PRELIMINARY DRAINAGE REPORT
for
THE COMMONS AT FALCON FIELD

El Paso County, Colorado

March 2024

PCD FILE NO. SP-232

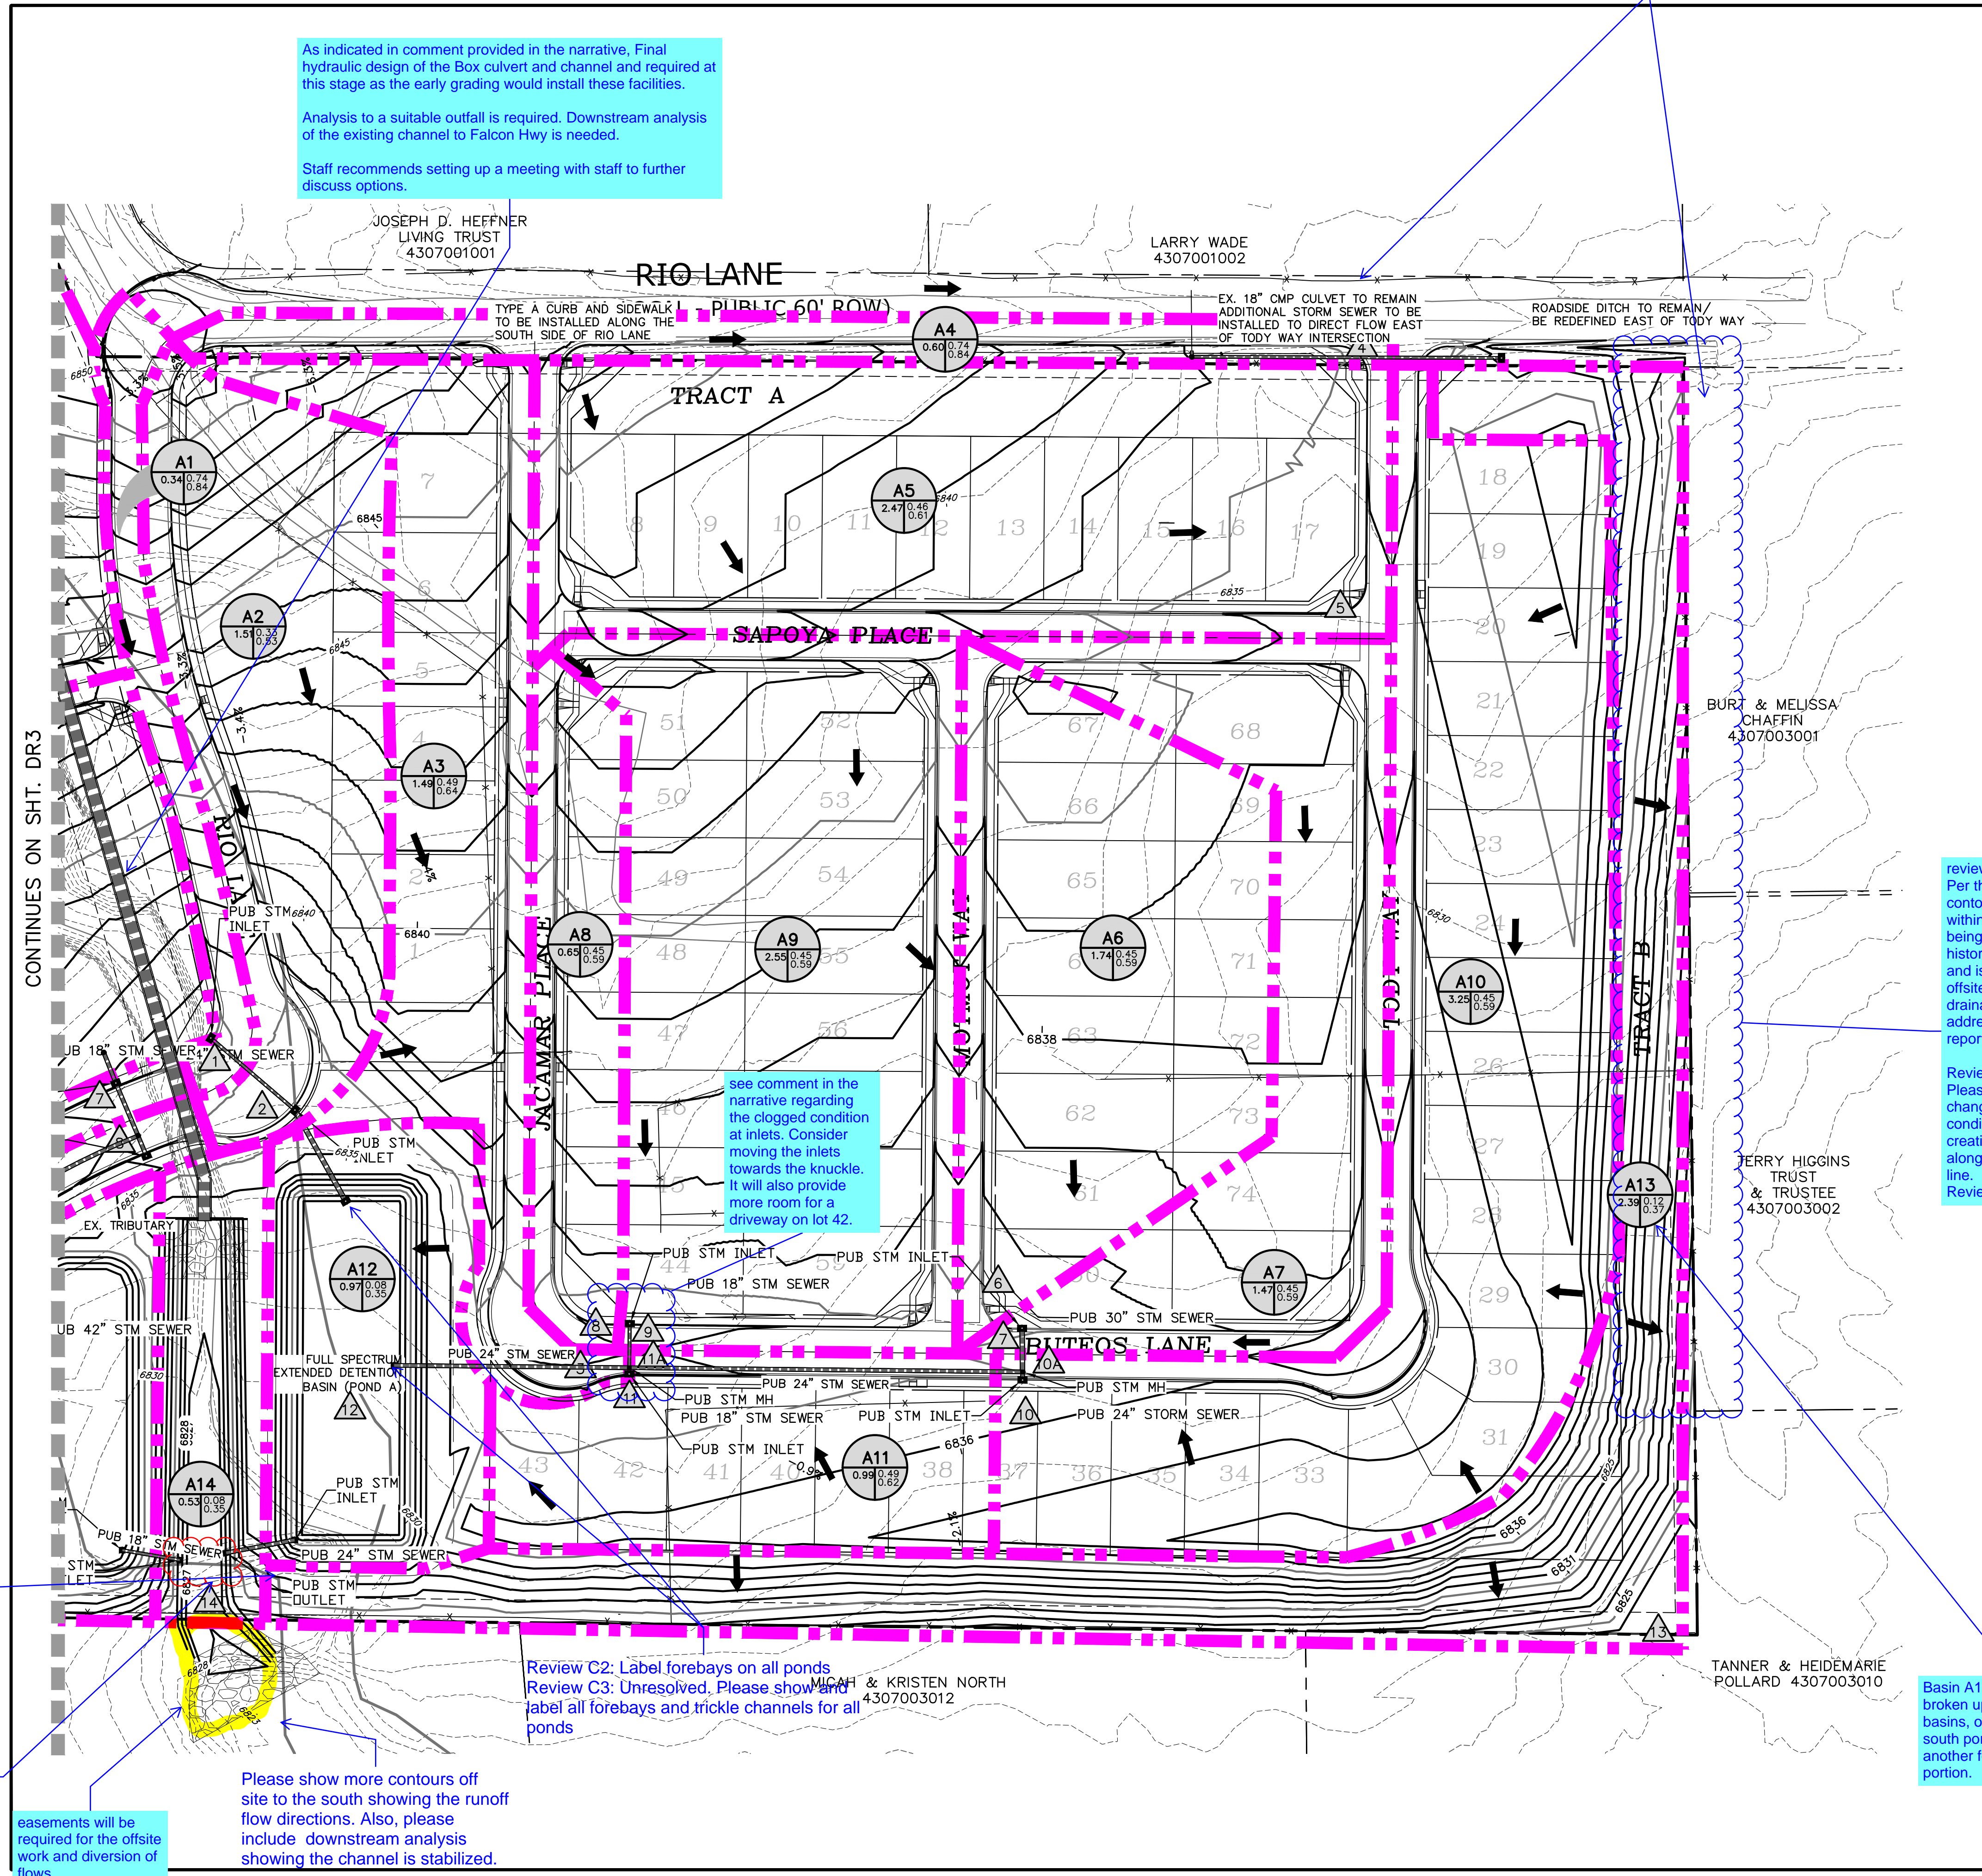
Please show and label emergency spillway. This comment is applied to all pond A, B, C.

Please show and label erosion protection at the outfall of two outlet pipes from Pond A, and B. Erosion protection must be installed to the toe of slope of the channel.

easements will be required for the offsite work and diversion of flows.

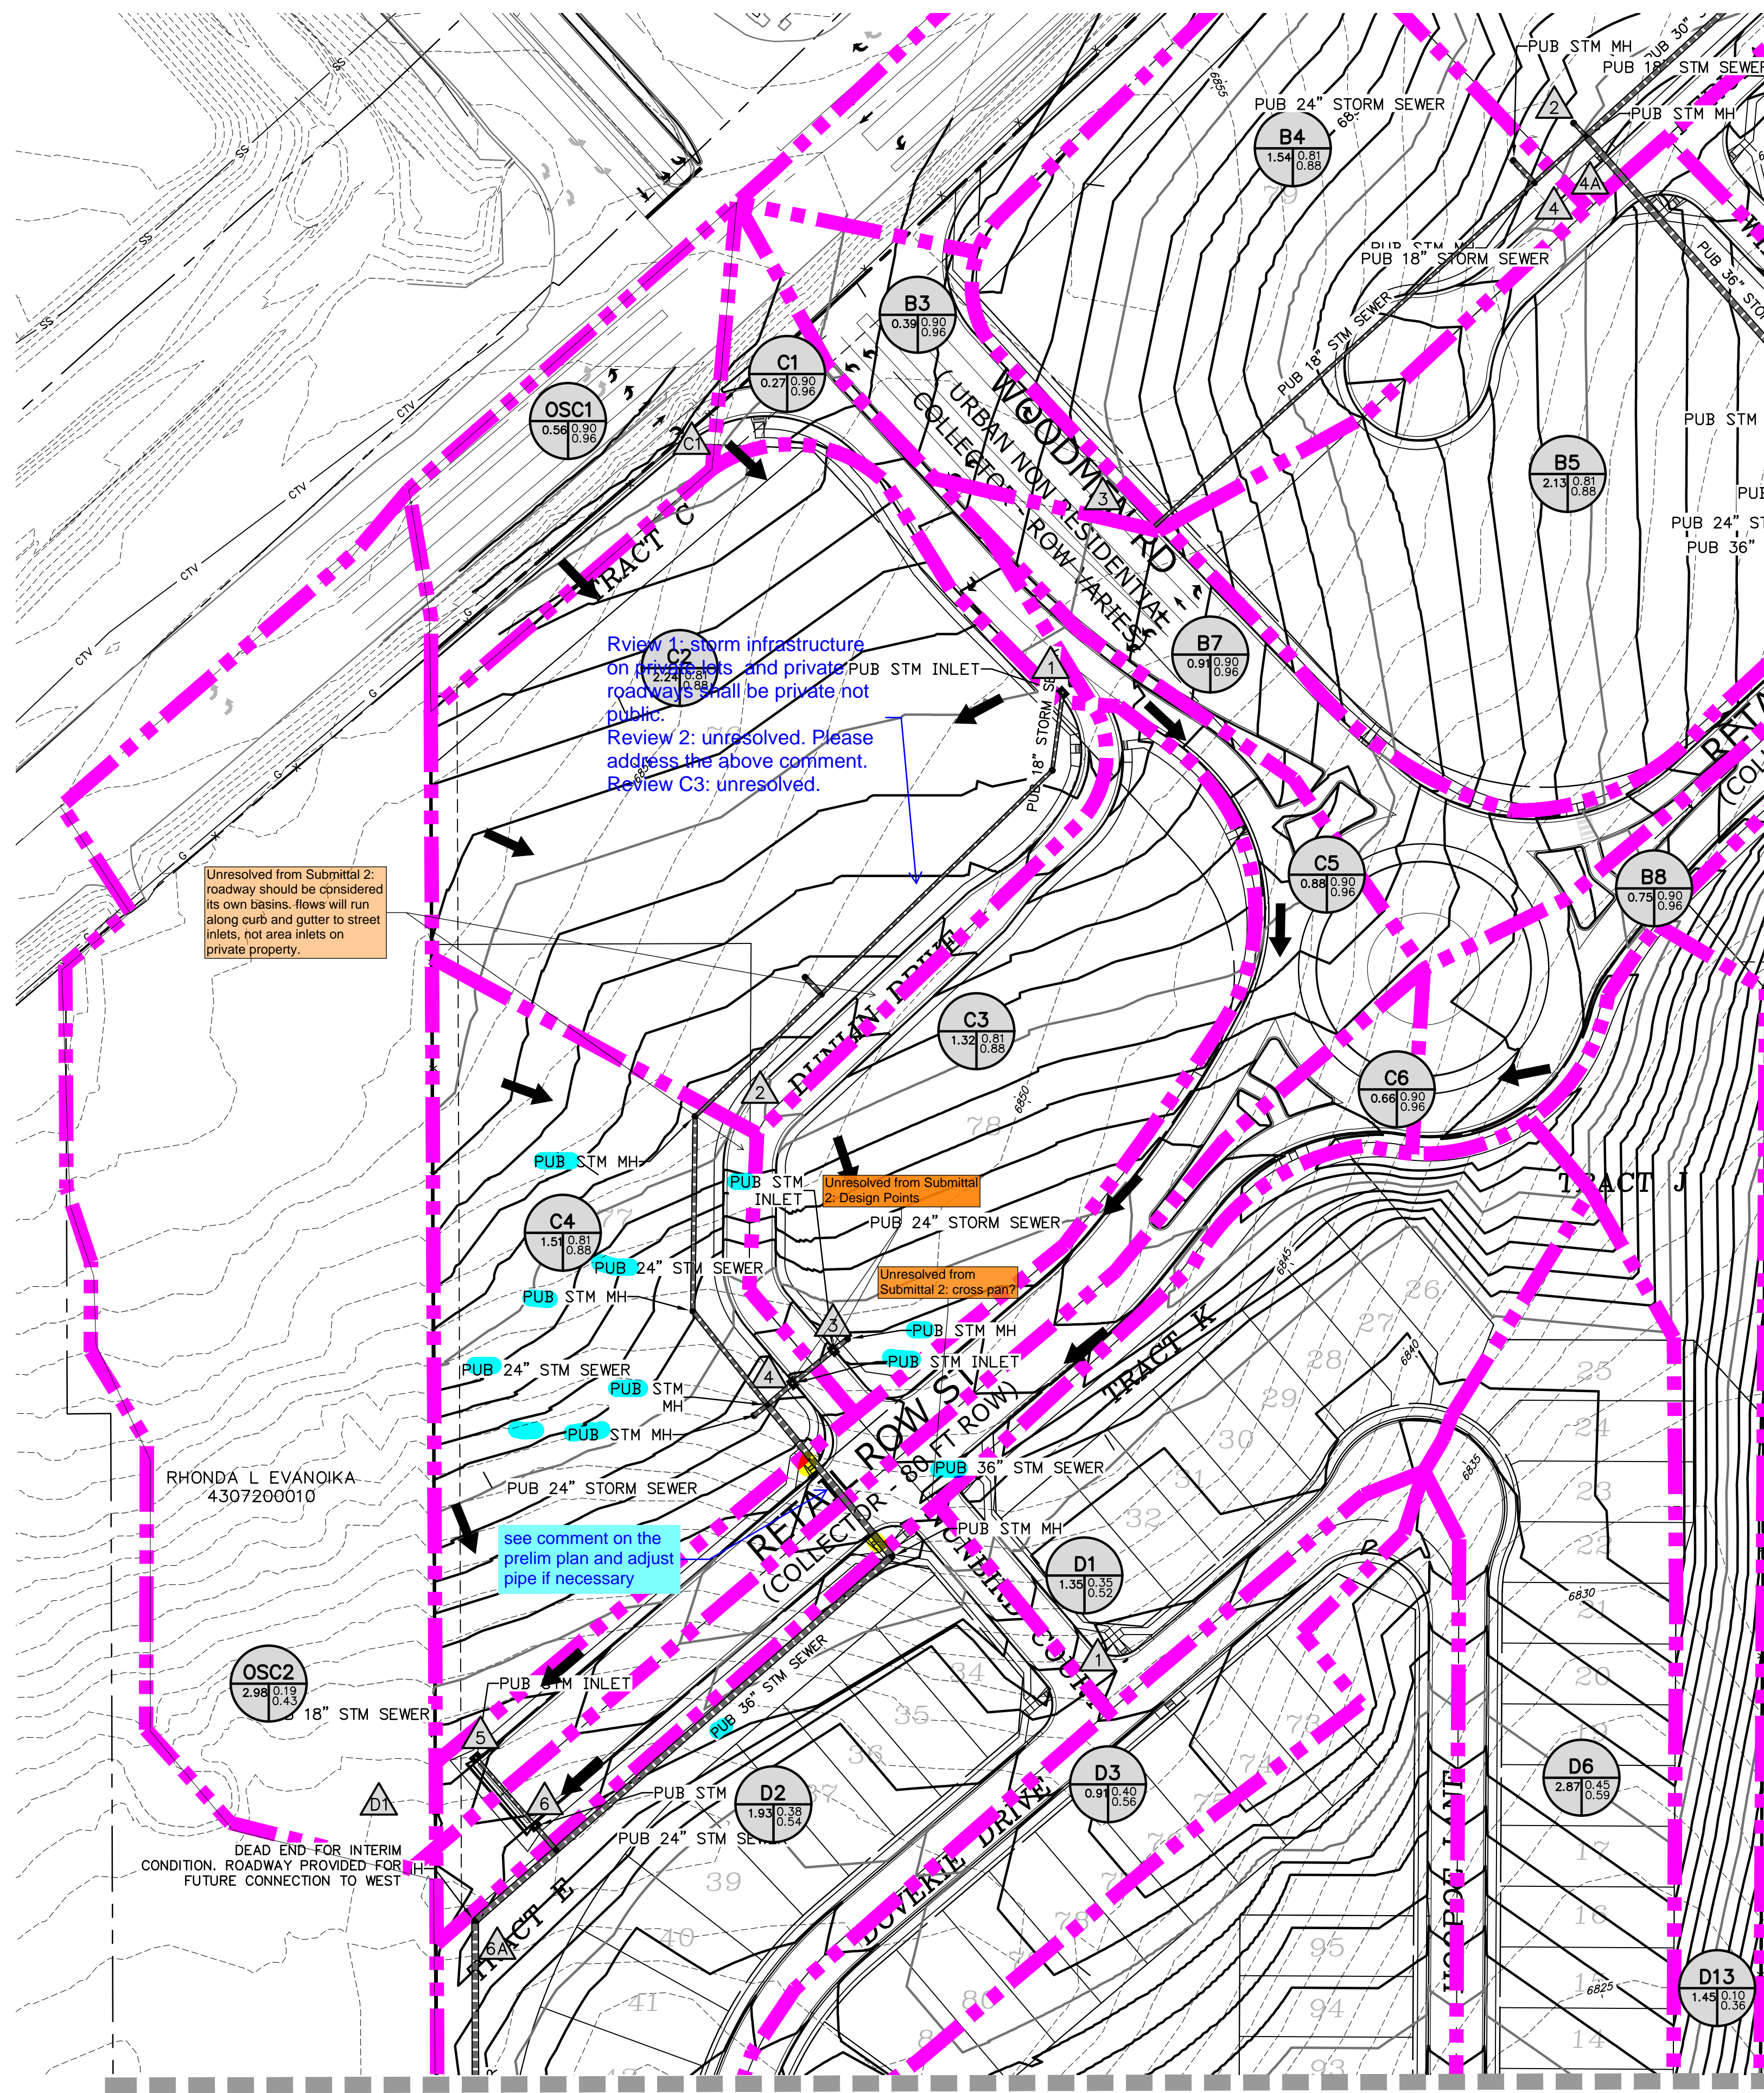
Please show more contours off site to the south showing the runoff flow directions. Also, please include downstream analysis showing the channel is stabilized.

Review C2: Label forebays on all ponds
 Review C3: Unresolved. Please show and label all forebays and trickle channels for all ponds

see comment in the narrative regarding the clogged condition at inlets. Consider moving the inlets towards the knuckle. It will also provide more room for a driveway on lot 42.

CONTINUED FROM SHT. DR4

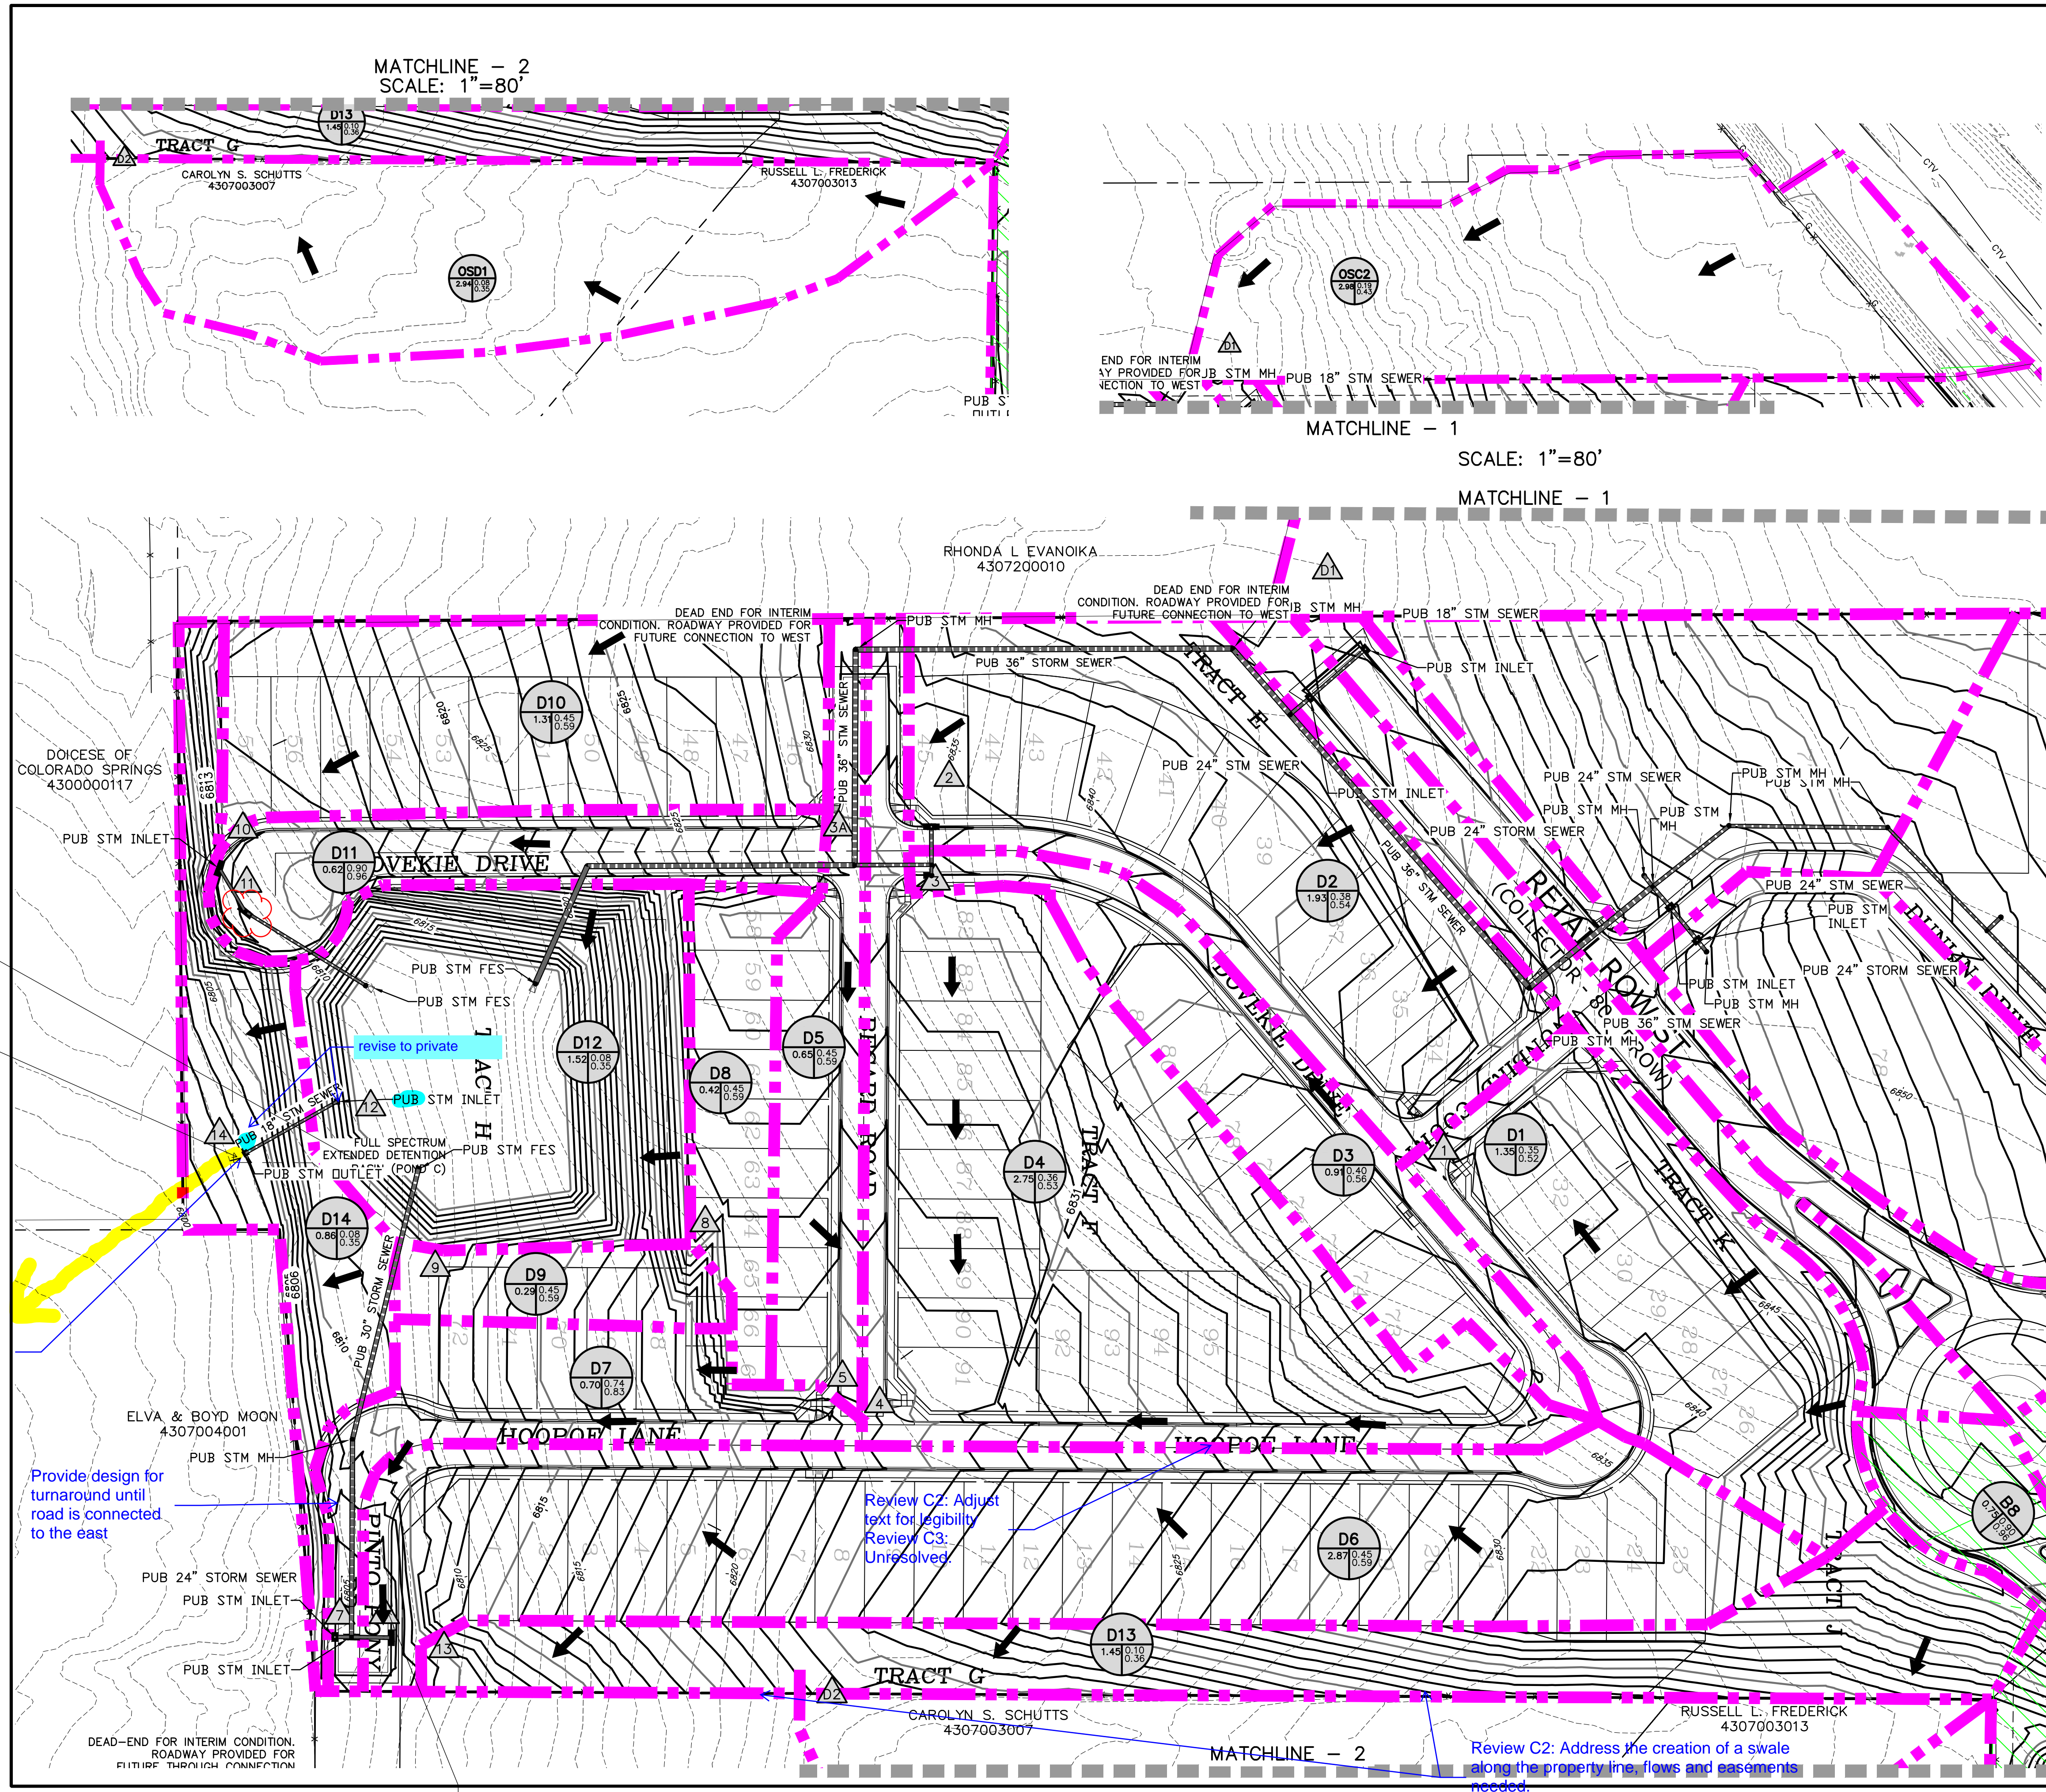
Unresolved from Submittal 2:
 adjust overlapping text

Review C2: show all
 necessary downstream
 conveyances and
 easements to an adequate
 suitable outfall.

Provide design for
 turnaround until
 road is connected
 to the east
